**Technical Service Bulletin (TSB)**  
**Interior Rear Facing Camera Bezel is Loose and or Falls Out of Headliner**

<b>REFERENCE:</b>	<b>TSB:</b> 23-009-23 <b>GROUP</b> 23 - Body	<b>Date:</b>	January 24, 2023	<b>REVISION:</b>	-
<b>VEHICLES AFFECTED:</b>	<b>2022 - 2023 (WS) Grand Wagoneer/Wagoneer</b> <b>NOTE:</b> This bulletin applies to vehicles built on or before August 01, 2022 (MDH 0801XX) equipped with an Interior Rear Facing Camera (Sales Code XPR).		<b>MARKET APPLICABILITY:</b> <input checked="" type="checkbox"/> NA <input type="checkbox"/> CH <input checked="" type="checkbox"/> EE <input checked="" type="checkbox"/> IAP <input checked="" type="checkbox"/> SA <input checked="" type="checkbox"/> MEA		
<b>CUSTOMER SYMPTOM:</b>	<b>Customers may comment on the following:</b> <ul style="list-style-type: none"> <li>The interior rear facing camera (FamCam) bezel, is loose and/or falls out of headliner (Fig. 1) .</li> </ul>				
<b>CAUSE:</b>	<b>Low retention force caused by retention clips at low end of tolerance.</b>

**Fig. 3**  
**Opening Retention Clip Nose And Gap**

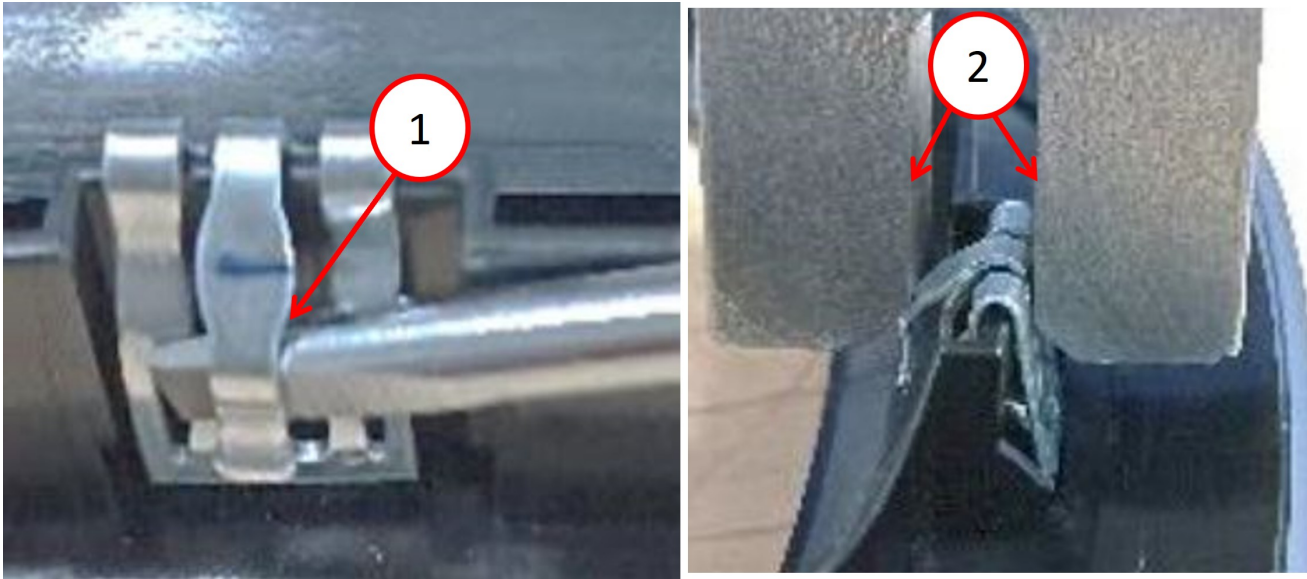
This bulletin involves inspecting the interior rear facing camera bezel for looseness and possibly removing and adjusting the retention clips for better retention.

1. Remove the interior rear facing camera bezel from the headliner (Fig. 1) by pulling down on each corner of the bezel.
2. Using a flat blade tool, gently open the nose of the retaining clip out to 8 mm (0.31 in.) (Fig. 3) .  
**Perform this step on each of the four retaining clip noses.**

- 1 - Retention Clip
- 2 - 8 mm (0.31 in.) Clip Gap
